Vine Transit Bus Maintenance Facility

Comments and Responses/Revisions to the
Draft Initial Study-Mitigated Negative Declaration

prepared by
Napa Valley Transportation Authority
625 Burnell Street
Napa, California 94559

prepared with the assistance of
Rincon Consultants, Inc.
449 15th Street, Suite 303
Oakland, California 94612

Figure 6: Plan for NVTA Bus Maintenance Facility

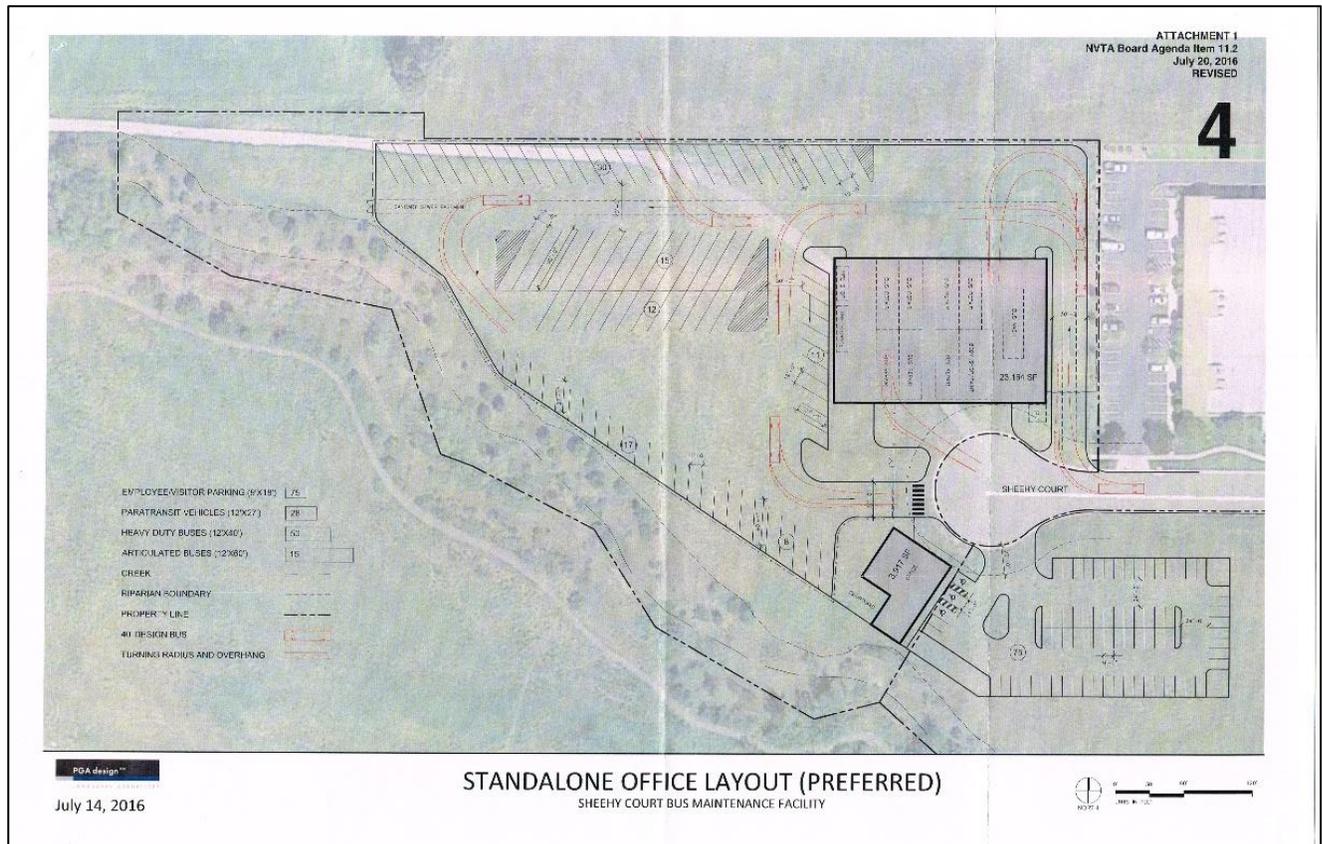
At the southeast corner of the Napa San property there are two parcels on Sheehy Court that are being purchased by the Napa Valley Transportation Authority (NVTA) for development of a bus maintenance and storage facility. The development plan includes a required setback from Sheehy Creek (see Figure 66).

Herb Fredericksen of NVTA said that the agency would be amenable to allowing the trail to cross through the creek setback area. The extension of the trail along the eastern boundary of the Napa San property would pass through an undeveloped buffer area, per NVTA's preferred layout plan (Figure 6).

The commenter’s request that the proposed project include two conceptual alignments for the Vine Trail is noted. This comment relates to the nature and merits of the project, rather than the analysis, conclusions or adequacy of the Draft IS-MND. Nevertheless, this comment will be forwarded to NVTA’s staff and board for consideration.

Figure 7: Option 1C – NVTA Property North Side of Sheehy Creek

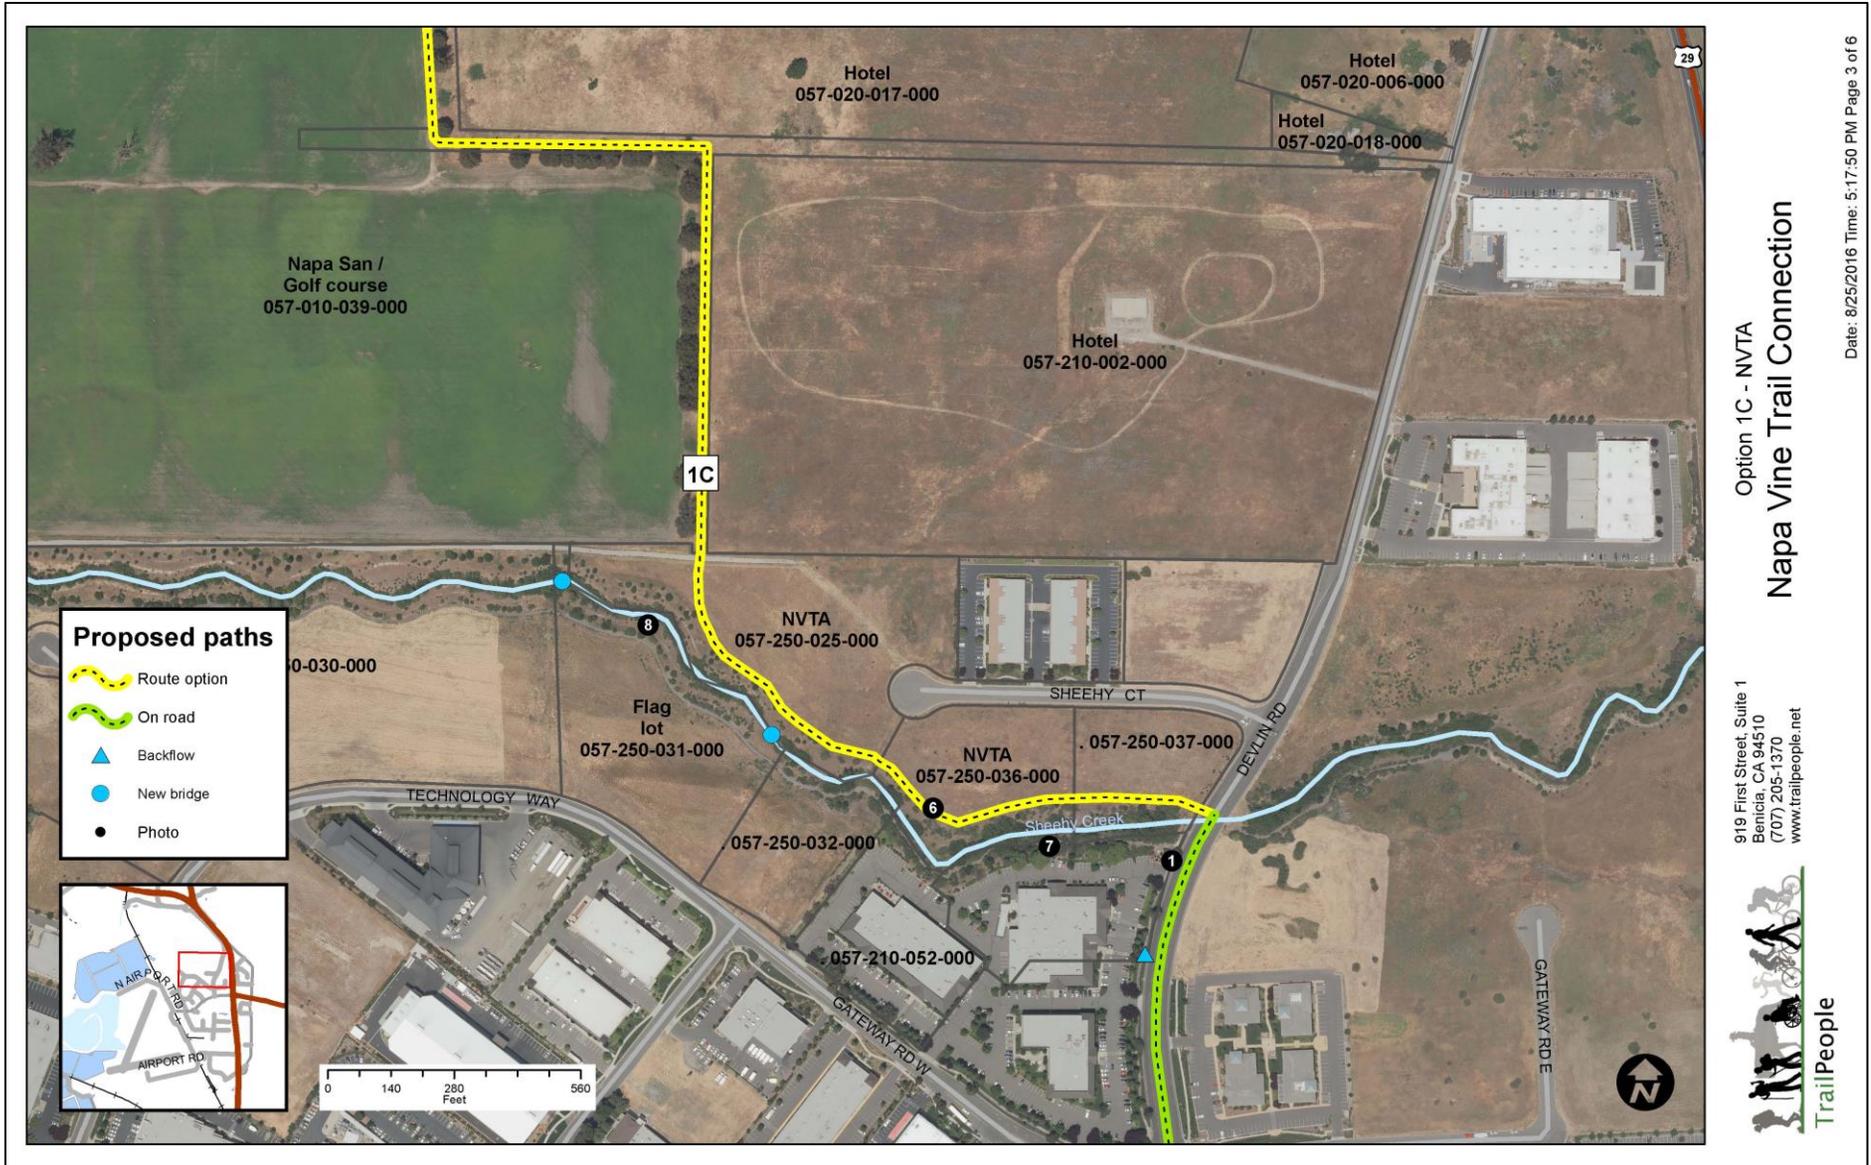
We respectfully request that the NVTA include both 1C and 1D alignments in the proposed plan and Negative Declaration.

If a trail corridor was provided along the north side of the creek (see Photo 6) this could provide access to Devlin Road, if it was also secured across a third undeveloped parcel, currently for sale, on the corner of Sheehy Court and Devlin Road. Alternatively, the trail could connect north on the east end of the NVTA parcels and extend east in the right-of-way of Sheehy Court, which would require a 10' wide sidewalk/path rather than the standard 6' sidewalk. There are no significant physical constraints to developing the trail on these alignments – it is a matter of acceptability to the property owners, the relative merits of the route for trail users, and potentially environmental issues associated with the creek. Figure 77 shows the route for this option.

Figure 8: Option 1D - Existing Path South of Sheehy Creek

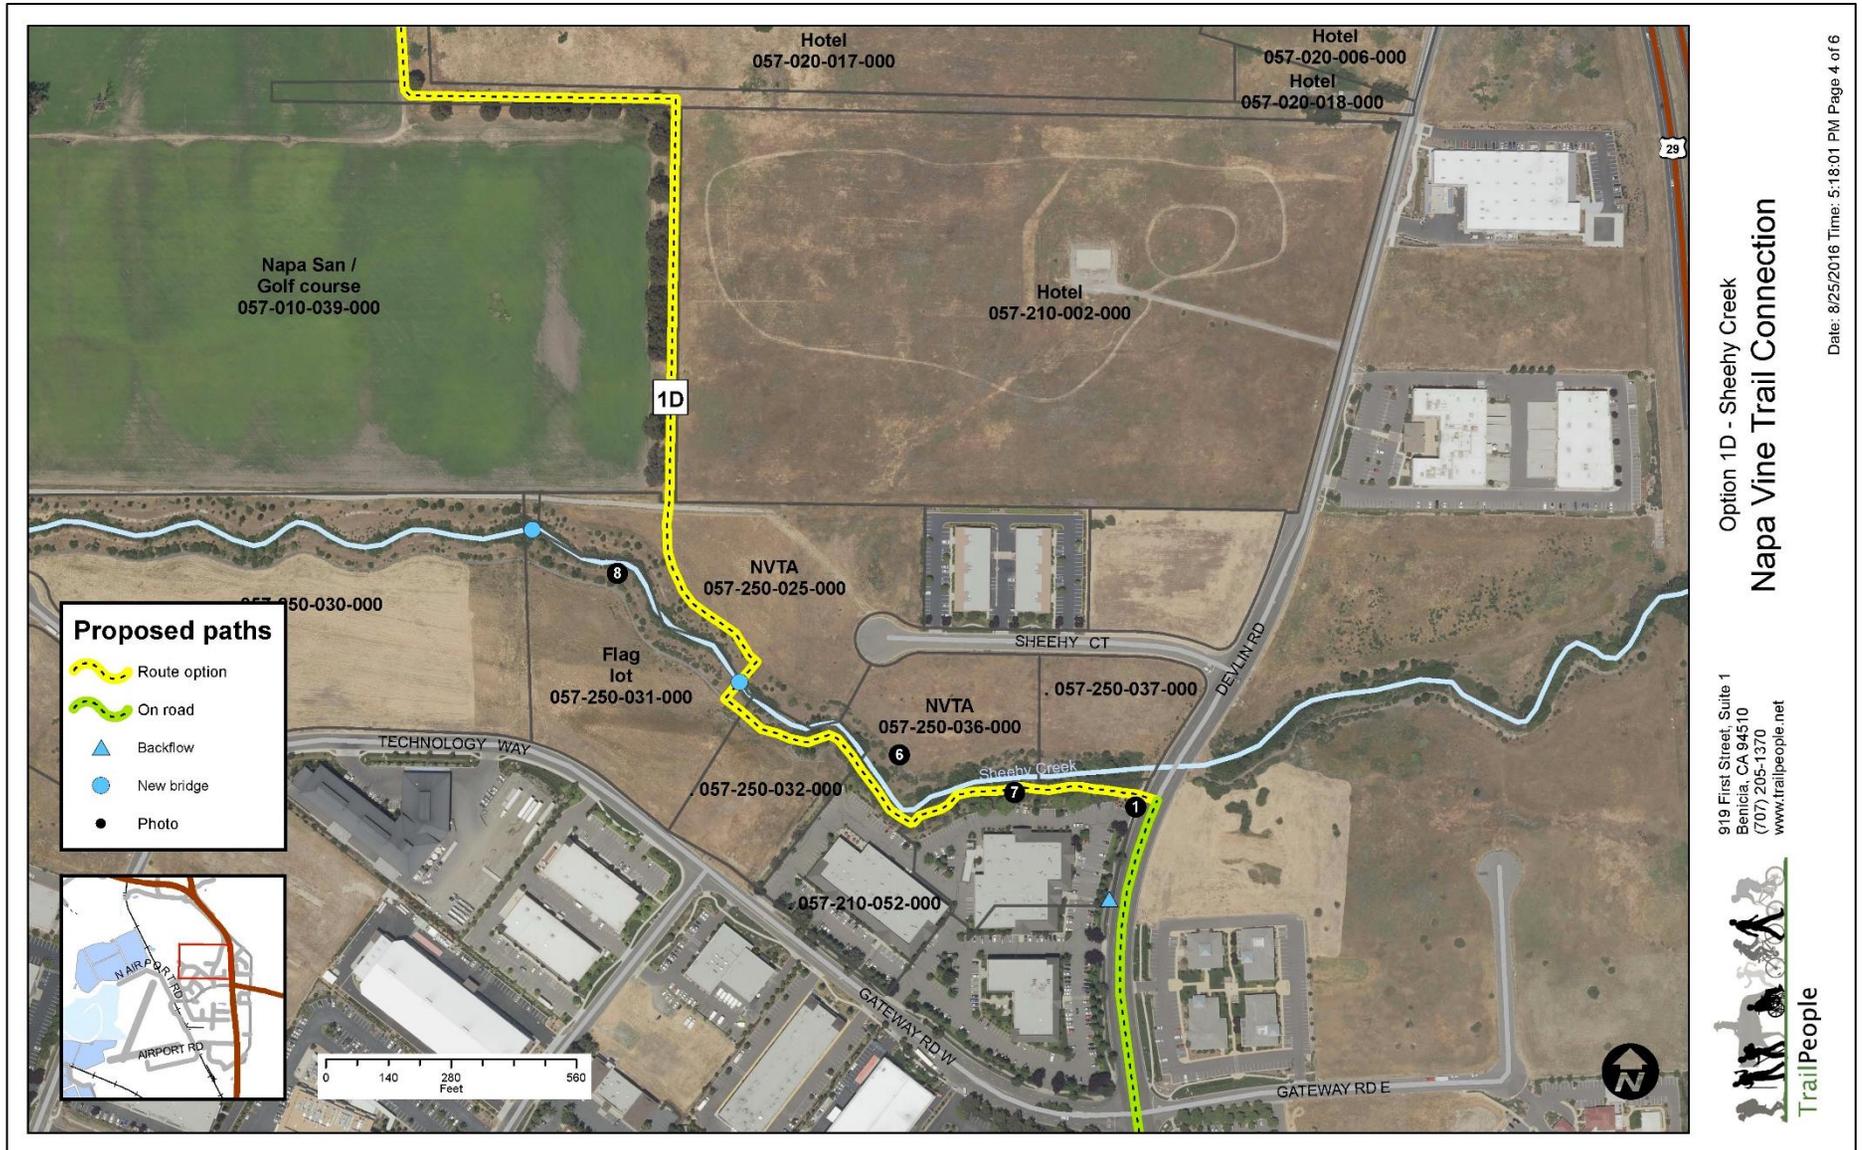
As an amenity for the development of the Airport business park, a nature trail and associated native tree plantings were developed along the south side of Sheehy Creek, extending on the east side of Devlin Road and on the west side from Devlin to west of Morris Court (see Figure 88). This trail is paved with asphalt approximately 6' wide (see Photo 7 below), versus the Vine Trail standard of a 10' width. It winds along the edge of the creek with turns that are tighter than desirable for a bike path. It exists in an easement that was granted to Napa County by the developer. The easement was modeled based on input from the U.S. Fish and Wildlife Service (USFWS) in conjunction with a U.S. Army Corps of Engineers permit for drainage work on an active stream. The easement excludes bicycles from the trail, and it would have to be modified (if possible) to convert the trail for multi-use.

Physically it is feasible to widen and straighten the trail and improve the sight distance without removing native trees. Existing baccharis/coyote brush shrubs would have to be trimmed back or removed. These are generally overgrown and woody dead branches from prior trimming for the trail. In addition to the easement modifications these changes would potentially require agreement from U.S. Fish and Wildlife Service and a Streambed Alteration Permit from California Department of Fish and Wildlife.
